**LIFE SAFETY ASSESSMENT
WESTERN STATE HOSPITAL
LAKEWOOD, WASHINGTON 98498**

**Prepared For
WASHINGTON DEPARTMENT OF SOCIAL
AND HEALTH SERVICES (DSHS)
1115 Washington St. SE
Olympia, WA 98504**

June 01, 2018

**JH Project #: 1SSD18011.000
RPA Contract #: 29431**

Figure 2: Snip from First Floor Bldg 9 to Bldg 17

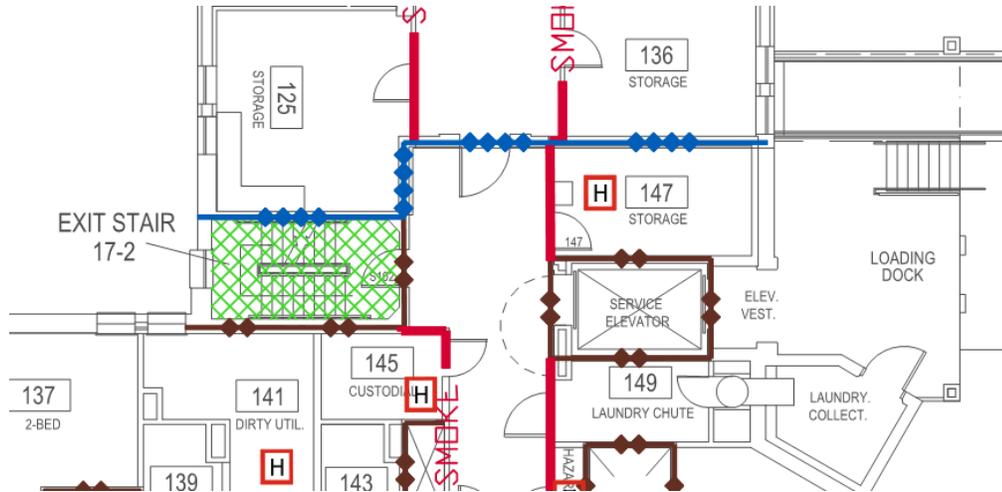
On the large inter-connected buildings: specifically, in between Buildings 28 and 29 and between Buildings 9, 17, 18, 19 and 20, a 4-hour fire barrier is listed on the existing life safety plans to separate each building. See Figure 2 below as an example (the navy-blue line type with 4 diamonds).

We suspect this is an attempt to meet the requirements of the 2015 IBC in terms of allowable area by introducing a catch-all wall type that separates buildings into smaller floor areas that meet the IBC allowable area tables. In the case of the example above (Building 9), there are 3-hour fire doors and a cast-in-place concrete wall at each floor that appears thick enough to meet a 4-hour rating. However, the walls have been cast in between floors and this wall does not provide the structural independence required of a true fire wall. In other cases (such as at Building 28 to 29) the doors in this location are only 20 minute-rated and the wall is a combination of cast in place and framed wall, not meeting a 4-hour separation.

The risk being run by continuing to call these walls 4-hour fire walls is that they will continue to incur comments, both in terms of the actual rating and the continuity requirements for fire walls which is not possible given existing construction.

When establishing type of construction for existing buildings, the better practice is to classify a building by what it can be based on applicable codes as opposed to what the building looks like based on observed construction. Due to the type of construction listed for most buildings as Type II, (see further in this report regarding Building 28) we recommend that these fire walls be re-designated to 2-hour fire/smoke barriers in order to meet the occupancy separation requirements of the LSC and better represent what these walls are actually accomplishing.

The justification is that the LSC does not limit the allowable area of buildings, only the allowable height, per Table 19.1.6.1. Since these building are all existing, they should not be required to meet the most current edition of IBC or its allowable area tables. However, in light of attempting to provide some form of separation, the IEBC (International Existing Building Code) Section 10.12.5.1.1 allows existing buildings to have fire walls constructed as fire barriers to meet the intent of building area separation. Since these buildings are being considered as Type II via the LSC, a 2-hour fire wall, or fire barrier in this case is allowed. We recommend the additional designation of smoke barrier to ensure that existing smoke compartment boundaries are not being violated.
